DEPARTMENT OF TRANSPORTATION**Federal Aviation Administration****14 CFR Part 93**

Noise Limitations for Aircraft Operations in the Vicinity of Grand Canyon National Park

ACTION: Final rule.

Figure 1. Comparison of GCNP Quiet Aircraft Technology Designation with Audibility

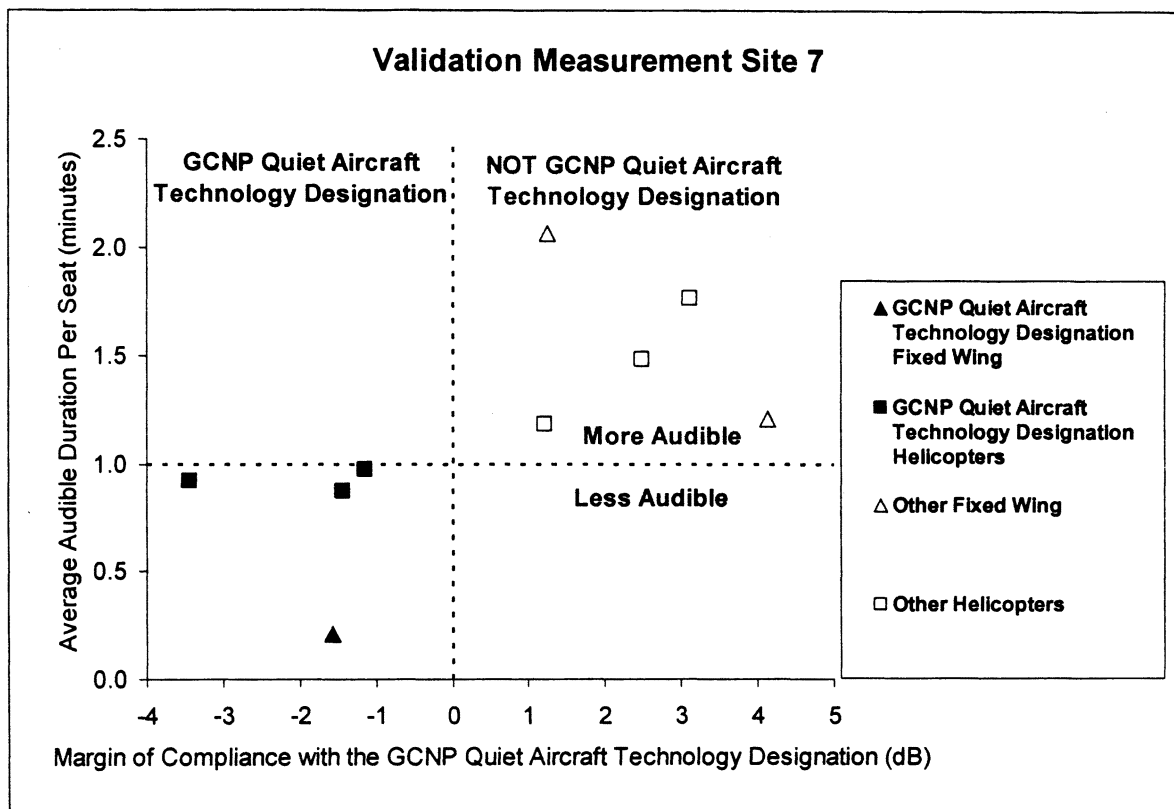
The NPS recommends that the FAA perform an analysis to ensure that aircraft that the FAA has classified as GCNP quiet aircraft technology based upon certificated noise levels are less audible than aircraft not so classified. The NPS included with its comment a technical memorandum, "Relationship Between Audibility of Tour Aircraft and Certification Data," prepared by the aviation environmental consulting firm, Harris Miller Miller & Hanson, Inc. (HMM&H).

Figure 1 compares the margins of compliance to the average length of time audible for the sample of aircraft at validation measurement Site 7. While Site 7 has been singled out for display, the findings are comparable to the other validation measurement sites. Site 7 included 6 microphone locations along Tanner Trail in the GCNP. The average audibility duration value at the 6 microphone locations is plotted for each of the aircraft types. The helicopters and fixed wing aircraft that meet the GCNP quiet aircraft technology designation are less audible than those aircraft that do not meet the designation.

The FAA analysis found that the GCNP quiet aircraft technology designation aircraft are less audible at all of the other model validation measurements sites. Table 1 summarizes the findings. The column on the far left of Table 1 contains the identity of the site groups used in the model validation study. That study grouped the 39 microphone locations according to common geographic characteristics that

The FAA concludes that while the correlation between ranking of certification noise levels and ranking of audibility duration is inexact, aircraft that meet the GCNP quiet aircraft technology designation are consistently less audible than those that do not. Therefore it is reasonable to expect that replacing non-compliant aircraft with larger, GCNP quiet aircraft technology designation aircraft (e.g., replace a
